**STAFF REPORT
KETCHUM PLANNING AND ZONING COMMISSION
REGULAR MEETING OF DECEMBER 15, 2020**

PROJECT: Decked Building Addition

FILE NUMBER: P20-078

APPLICATION TYPE: Design Review

PROPOSED ELEVATION - WEST SCALE: 1/4" = 1'-0"

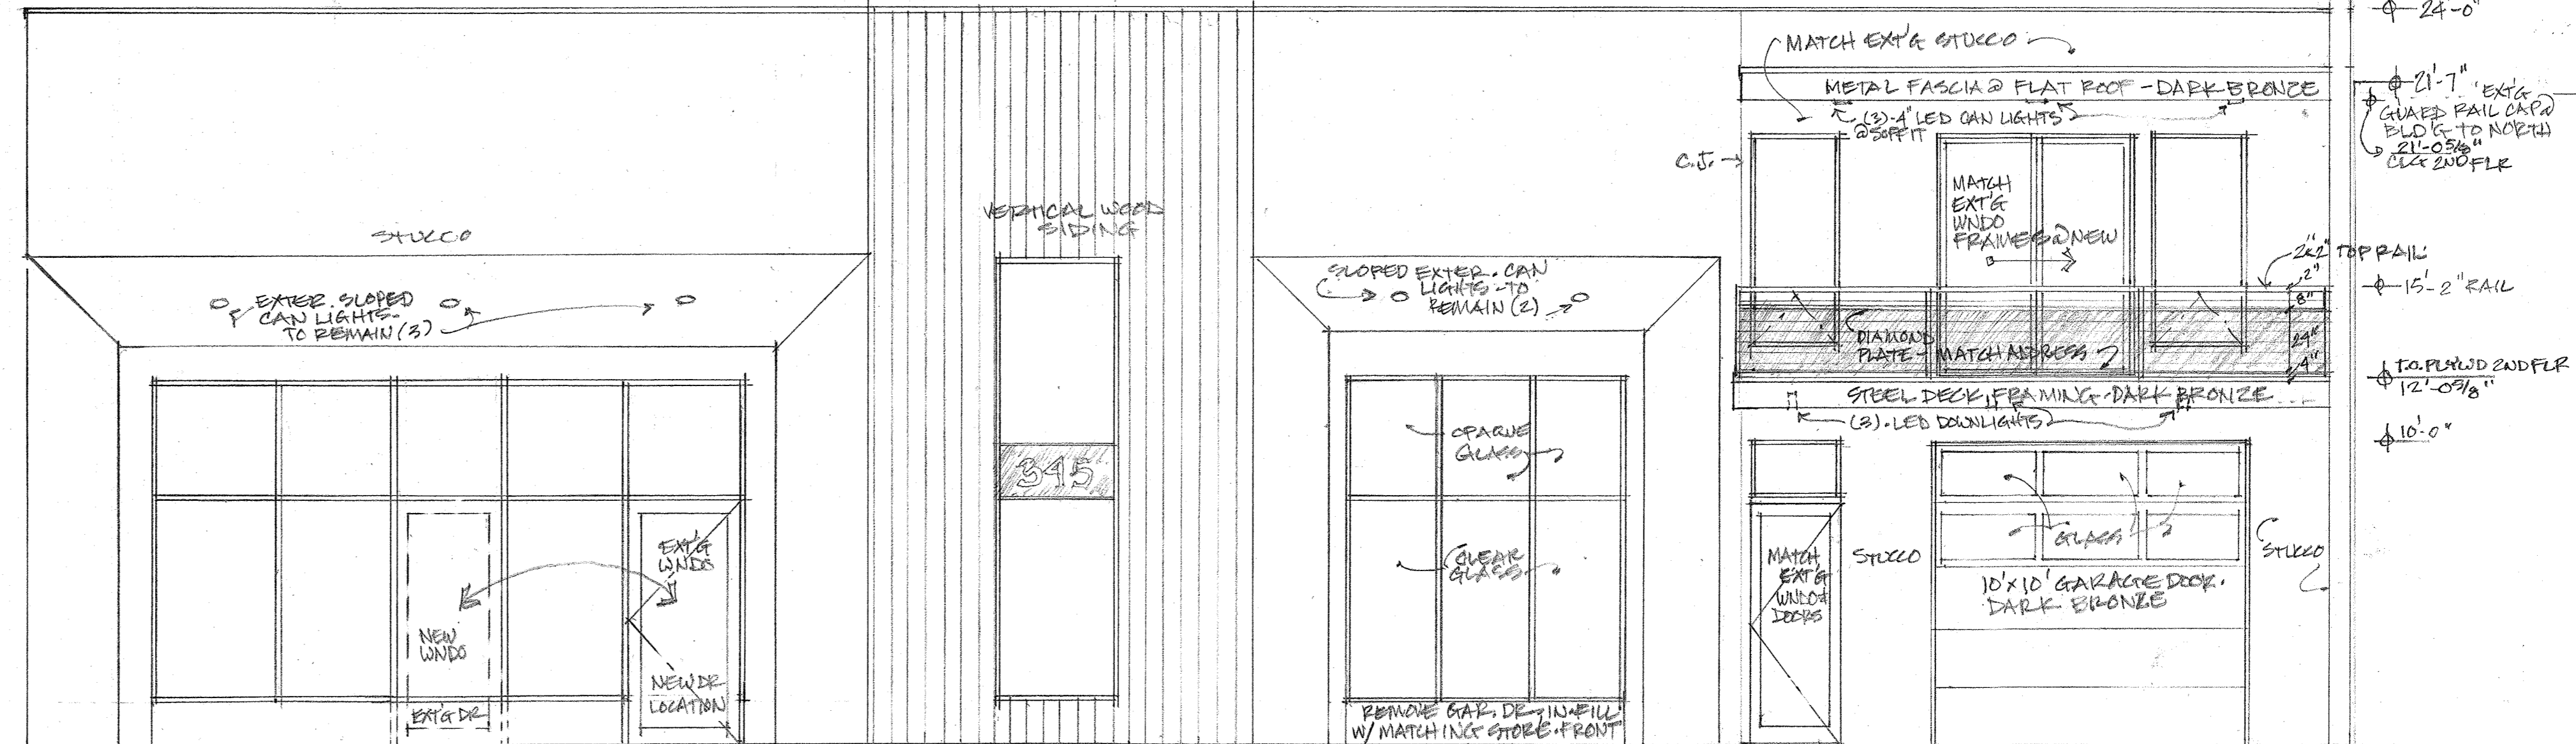
<input checked="" type="checkbox"/>	<input type="checkbox"/>	<input type="checkbox"/>	17.96.060.F5	Building walls shall provide undulation/relief, thus reducing the appearance of bulk and flatness.
			Staff Comments	The proposed elevation views provided by the applicant show that all building walls provide undulation and relief, serving to reduce the appearance of bulk and flatness at all façades. The façades combine horizontal and vertical elements with one- and two-story elements through the variation of siding and exterior materials, projecting elements, and fenestration provided through multiple window and door openings. The addition project will add more character and visual texture to the front façade. The two-story addition includes combines a garage door on the first level with a cantilevered deck and large rectangular windows at the second level to add visual interest. The existing vertical wood siding in the middle of the front façade further distinguishes this light industrial building.
